Access Compliance Report Public Rights-of-Way (Curb Ramps)

Main Street: **RADIANCE_LN** Cross Street: **RADIANCE_LN** Location: **NW**

ADA ID: **RPRK211019181631** Ramp Type: **Type 4 - Parallel** Initial Pass/Fail: **Fail** Overall Compliance: **No** Severity Score: **19**

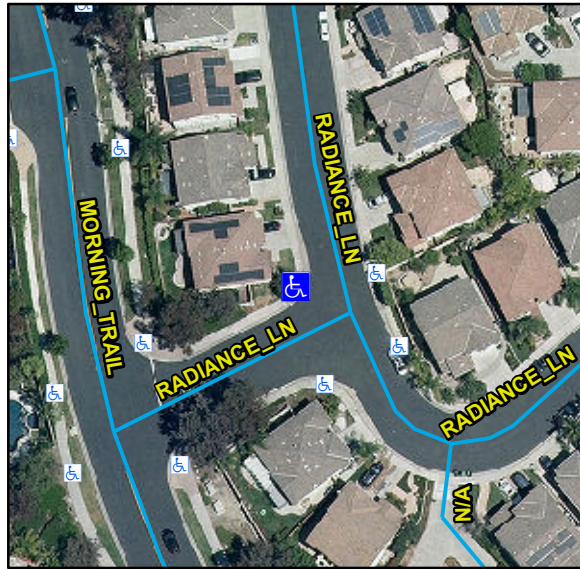
Compliance	Description	Data	Compliance	Description	Data
N/A	Ramp Length LT (in)	116	N/A	Ramp Length RT (in)	122
No	Ramp Width LT (in)	47	No	Ramp Width RT (in)	47
No	Ramp Run Slope LT (%)	10.7	Yes	Ramp Run Slope RT (%)	1
Yes	Ramp Cross Slope LT (%)	0.2	Yes	Ramp Cross Slope RT (%)	1.9
N/A	Landing Present	N/A	N/A	DWS Provided	N/A
N/A	Landing Length (in)	N/A	N/A	DWS Contrast	N/A
N/A	Landing Width (in)	N/A	N/A	DWS Length (in)	N/A
N/A	Landing Run Slope (%)	N/A	N/A	DWS Full Width	N/A
N/A	Landing Cross Slope (%)	N/A		DWS Offset Type	N/A
N/A	Landing Movement Obstructed?	N/A	N/A	DWS Offset Left (in)	N/A
	Landing Movement Type	N/A	N/A	DWS Offset Right (in)	N/A
N/A	Landing Shared	N/A			
N/A	Clear Space	Yes			
N/A	Clear Space To Crosswalk (in)	N/A			
N/A	Marked Crosswalk 1	No	N/A	Marked Crosswalk 2	No
	Crossing 1 Direction	S		Crossing 2 Direction	E
	Marked Crosswalk 1 Width (in)	N/A		Marked Crosswalk 2 Width (in)	N/A
N/A	Ramp Inside Crosswalk 1	N/A	N/A	Ramp Inside Crosswalk 2	N/A

Remove & Replace Curb Ramp With Two New Directional Ramps or Equivalent.
